1. Address/Description: 515 VILLITA ST
HDRC Case No.: 2024-053
Historic District Name: La Villita
RIO District: RIO-3
Applicant: Samuel Panchevre/Alamo City Investments
Request: Construction of a terrace on the river side, installation of graphics and signage
City Council Dist.: 1

HISTORIC AND DESIGN REVIEW COMMISSION

February 21, 2024

HDRC CASE NO: 2024-053
ADDRESS: 515 VILLITA ST
LEGAL DESCRIPTION: NCB 142 BLK LOT 11
ZONING: D, H, RIO-3
CITY COUNCIL DIST.: 1
DISTRICT: La Villita Historic District
APPLICANT: Samuel Panchevre/Alamo City Investments
OWNER: San Antonio Conservation Society Panchevre/Casa Catrina
TYPE OF WORK: Construction of a terrace on the river side, installation of graphics and signage
APPLICATION RECEIVED: January 24, 2024
60-DAY REVIEW: March 24, 2024
CASE MANAGER: Edward Hall
REQUEST:

Gazebo Casa Catrina

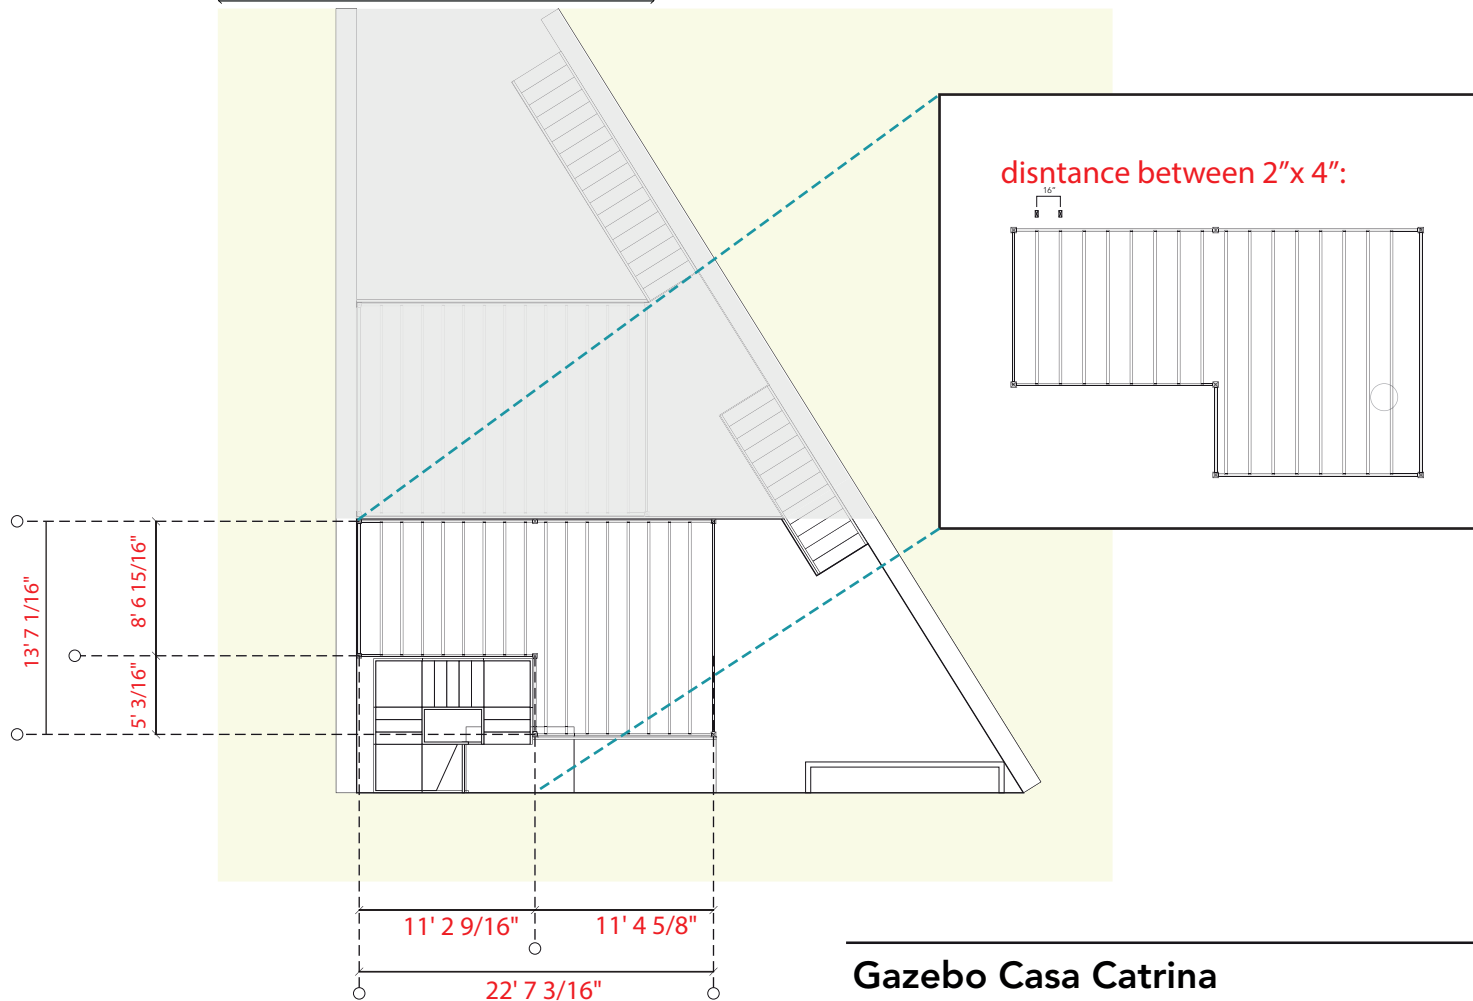
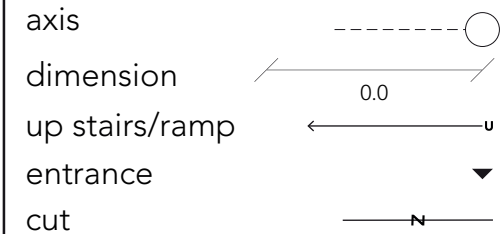
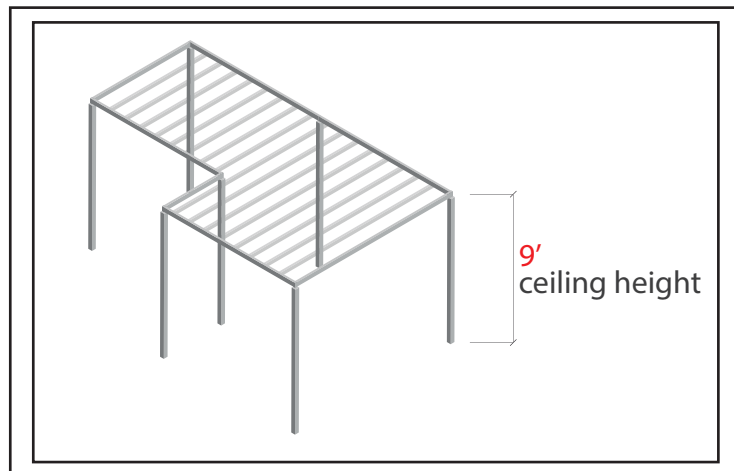
- c. TRELLISES – The applicant has proposed to construct a series of metal trellis structures to provide cover and shade for the terraced seating area on the river side of the property. The applicant has proposed for the trellises to be constructed of metal, featuring 4x4 metal columns with both metal perimeter beams and wood interior beams, and to be painted gray. The applicant has noted that the trellis structures will feature varying heights of eight (8) to nine (9) feet. The applicant has noted that the design will accommodate a water feature; however, the applicant has not provided additional information on this. Generally, staff finds the proposed trellis structure to be appropriate. All elements should be painted to complement the existing tones and colors found historically on site. The installation of the proposed trellis structures should not result in rainwater draining onto the public pathway at the River Walk.

- 1. Staff recommends approval of item #1, the construction of a series of metal trellises based on finding c, with the following stipulations:
 - i. That the trellises be painted to complement the existing tones and colors found historically on site.
 - ii. The installation of the proposed trellis structures should not result in rainwater draining onto the public pathway at the River Walk.
- 2. Staff recommends approval of item #2, the installation of wood railings based on finding d with the stipulation that bolts are installed in mortar joints rather than through stone elements.

Casa Catrina Logo

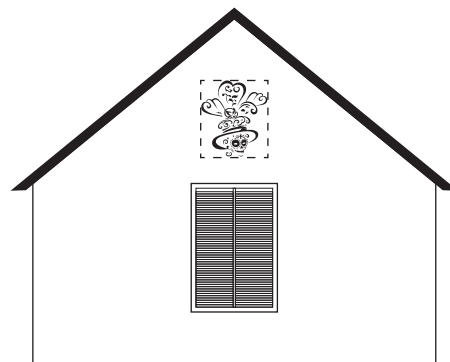
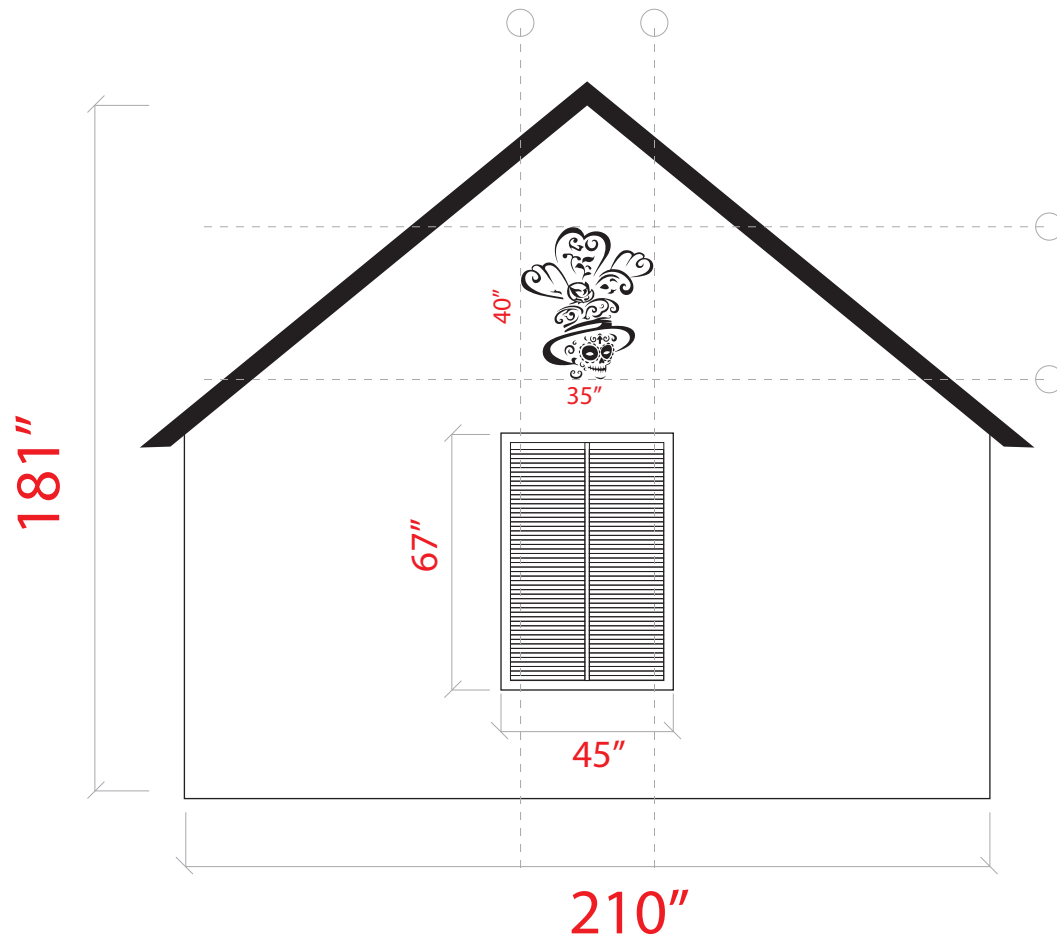
- e. BALCONY LEVEL SIGNAGE – The applicant has proposed to install balcony level signage facing Villita Street. Generally, staff finds balcony level signage to be appropriate; however, staff finds that the signage should be installed as a hanging sign rather than applied to the balcony wall. Historically, balcony level signage is installed in this manner.

- f. GABLE SIGN – The applicant has proposed to install one wall sign beneath the street facing gable. The Guidelines for Signage notes that wall signs should be located on building forms that historically featured wall signs. Generally, staff finds this location to be inconsistent with the Guidelines as signage did not exist here historically. Staff recommends this sign be eliminated.

3. Staff recommends approval of item #3, the installation of balcony level signage with the stipulation that the signage be installed as hanging signage and not wall signage.
4. Staff does not recommend approval of item #4, the installation of a graphic/sign beneath the gable. Staff does not find this signage location to be consistent with the Guidelines nor appropriate within the La Villita Historic District.
